STAFF RECOMMENDATION
1824 5th Avenue North
June 19, 2019

Application: New Construction—Addition and Outbuildings; Setback Determination
District: Salemtn Neighborhood Conservation Zoning Overlay
Council District: 19
Base Zoning: R6-A
Map and Parcel Number: 08108027000
Applicant: Jeff Zeitlin, Developer
Project Lead: Paul Hoffman, paul.hoffman@nashville.gov

Description of Project: This application is for a rear addition and two carports at the rear of the lot. The applicant requests a setback determination for the addition's left side, from five feet (5') to three feet (3').

Figure 2: Different outbuildings were in place in 1957.

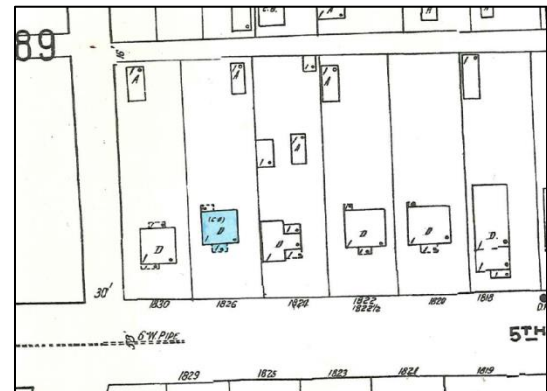
Demolition: An existing outbuilding is proposed to be removed. The exact date of construction is unknown, but it does not appear on the 1957 Sanborn map (Figure 2). The outbuilding does not contribute to the architectural or historical integrity of the district. As the addition is proposed for a second unit, the demolition plan does not include significant removal of the rear of the house. Staff finds that the proposed demolition of the outbuilding meets Section V.B.2 of the design guidelines for appropriate demolition, and does not meet Section V.B.1 for inappropriate demolition.

Figure 3: 2013 photo shows chimney in place at that time.

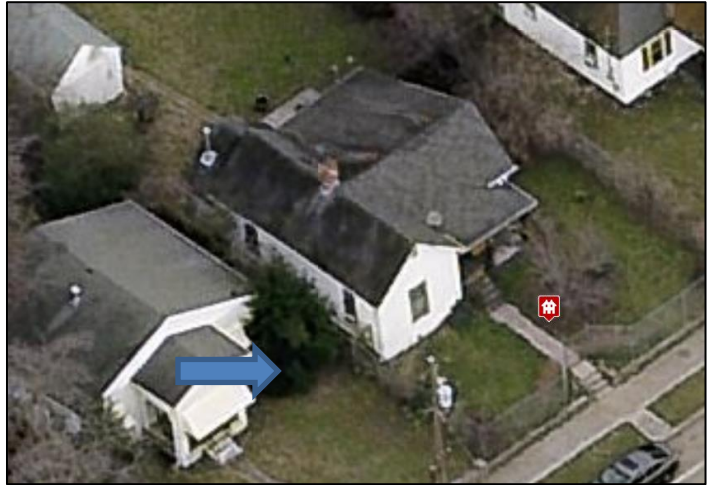
only minimally taller, the difference will not be greatly perceived from the right-of-way. A new chimney is drawn on the existing house, at the intersection of the ridges. A previous chimney was removed in 2013 or early 2014, prior to the establishment of the overlay. (Figure 3). The new chimney is in the same location as the historic chimney, so staff finds its reconstruction appropriate. The proposed roof forms are commonly found in the district, and are compatible with the existing structure. Staff finds that the roofs of the addition meet Section II.B of the design guidelines.
